TOWN OF DELAFIELD PLAN COMMISSION MEETING

Tuesday, August 2, 2022, 6:30 p.m.

Plan Commission Report for August 2, 2022

TOY BOX - LYNNDALE ROAD
TOWN OF DELAFIELD, WISCONSIN

1 PROPOSED SITE LIGHTING PLAN

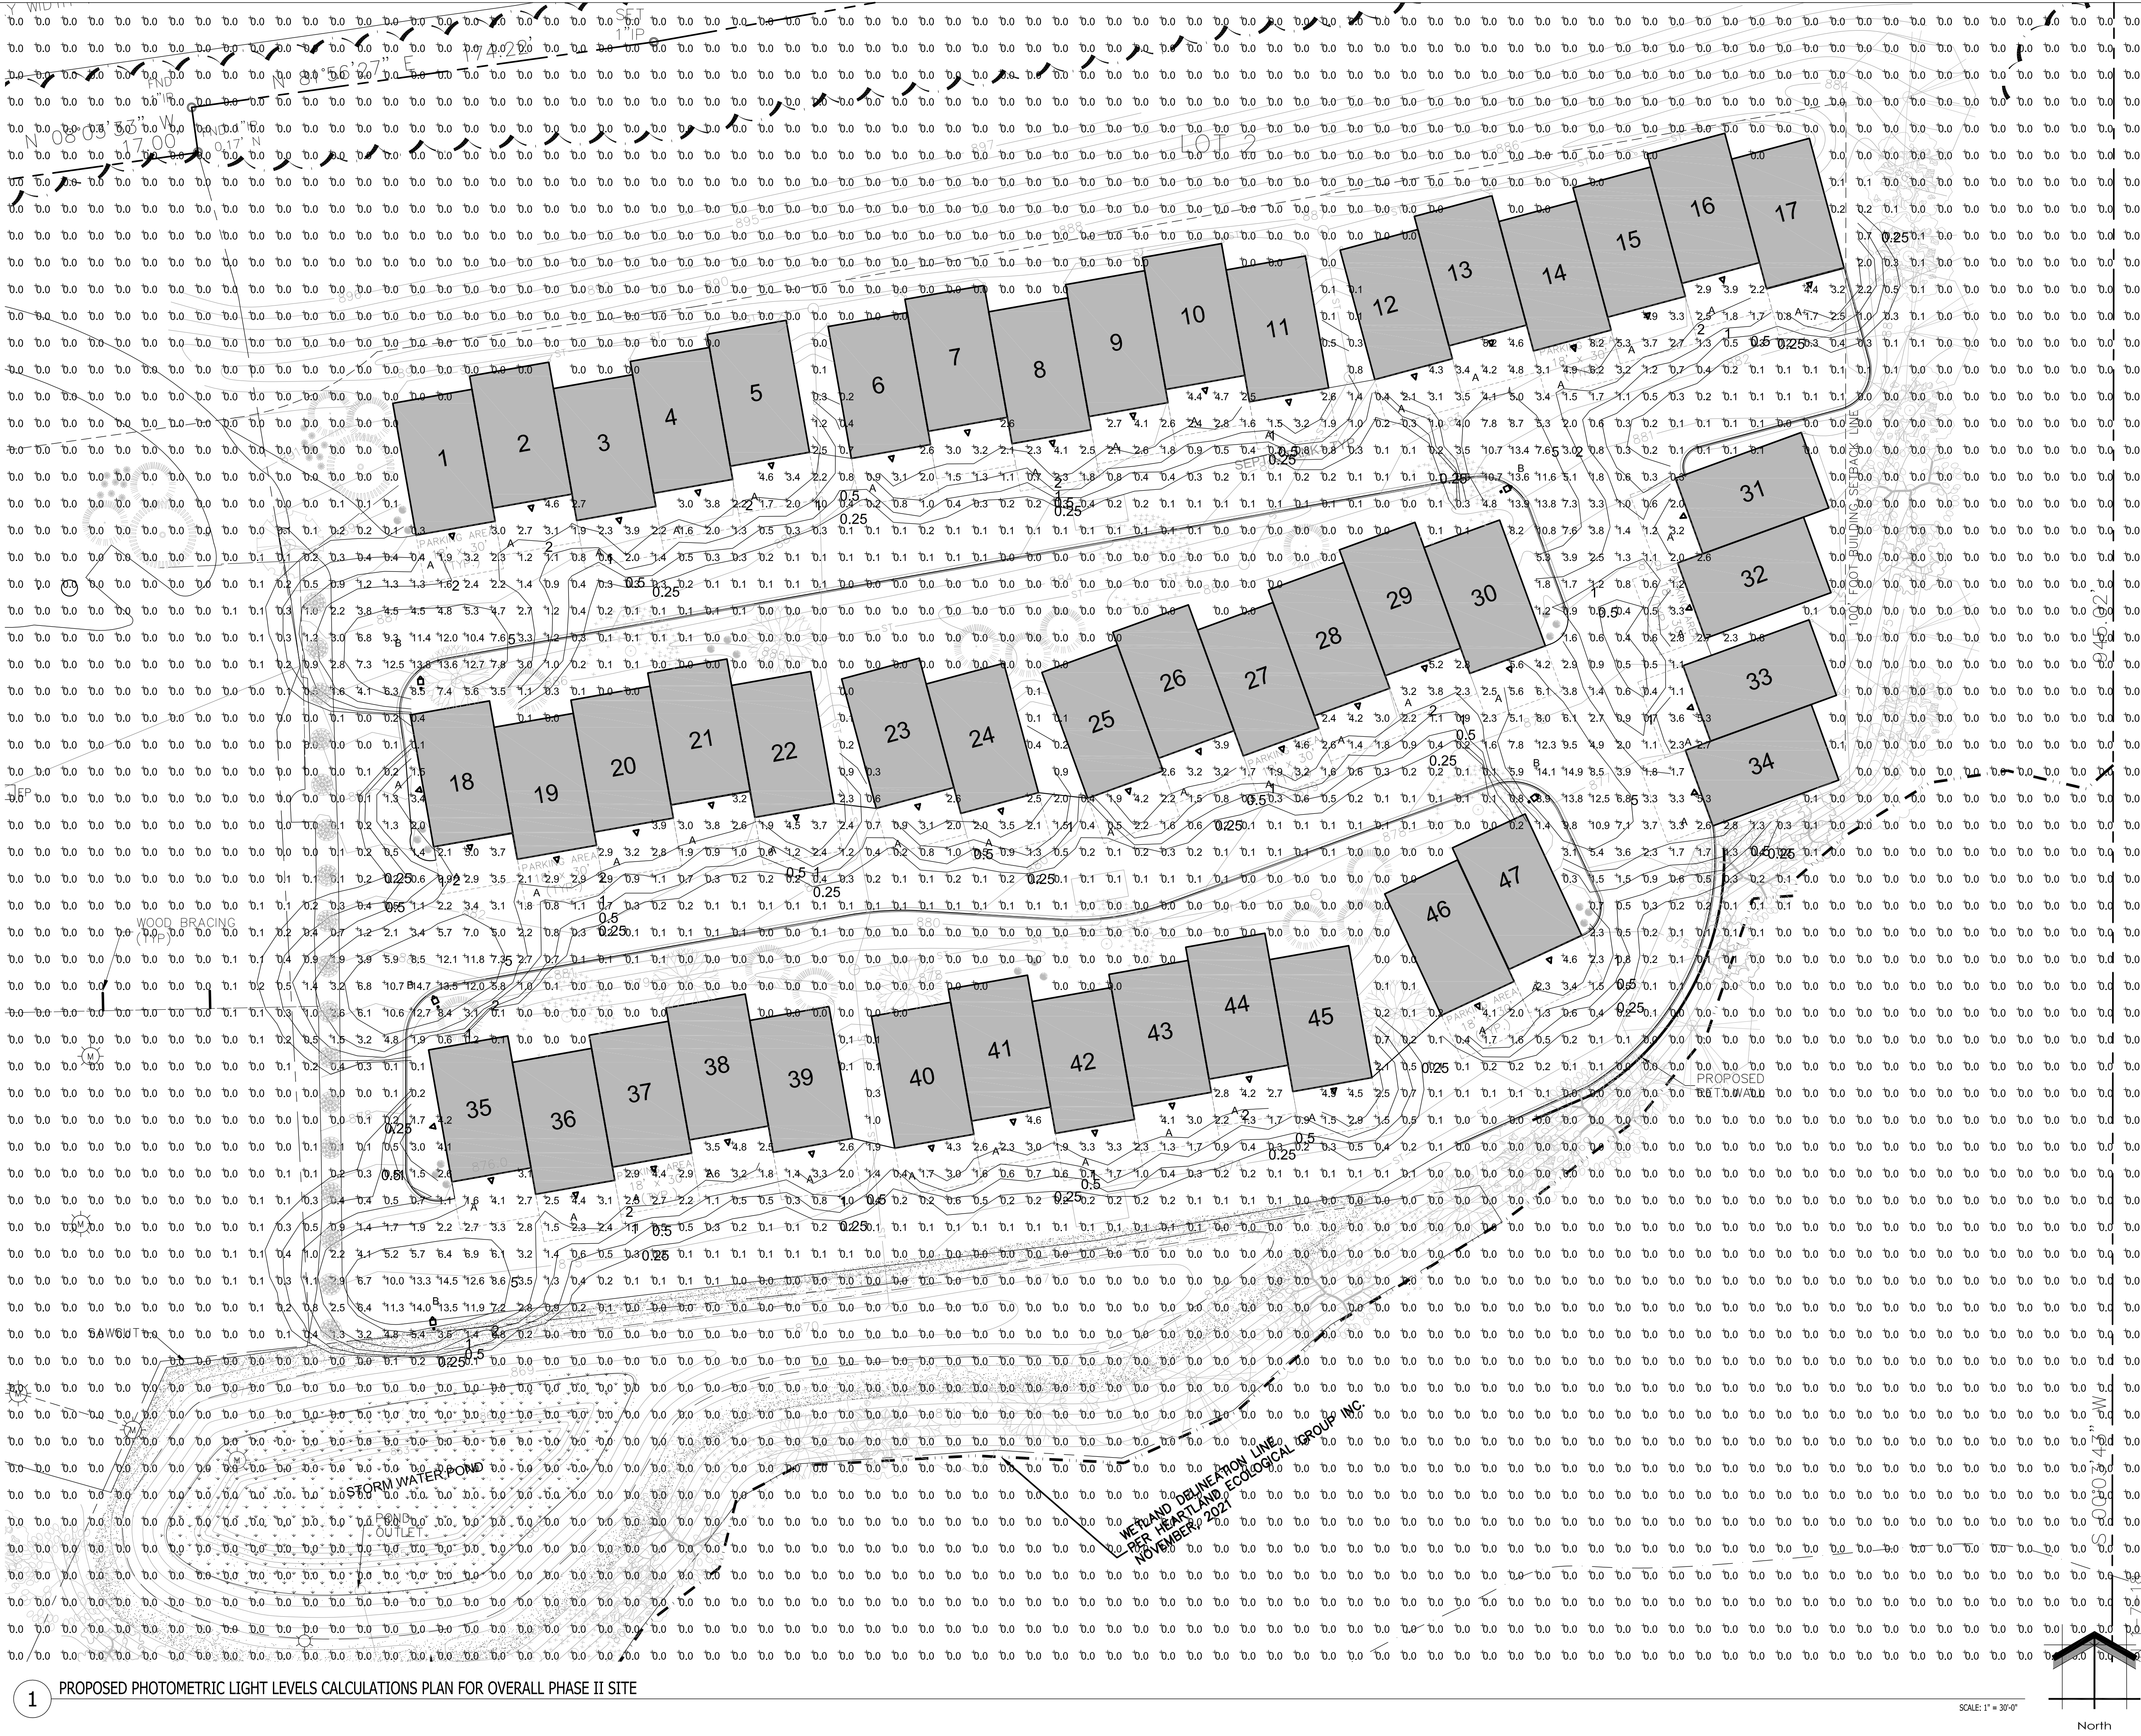
20. Luminaries attached to buildings shall not exceed 16 feet in height.

Response: Luminaire Schedule note #7 states: All building mounted light fixtures are to be coordinated with the architectural drawings. The mezzanine elevation above the overhead door is listed to be 112'-0". The overhead door fixtures will be mounted below the mezzanine, recessed or on the vertical surface
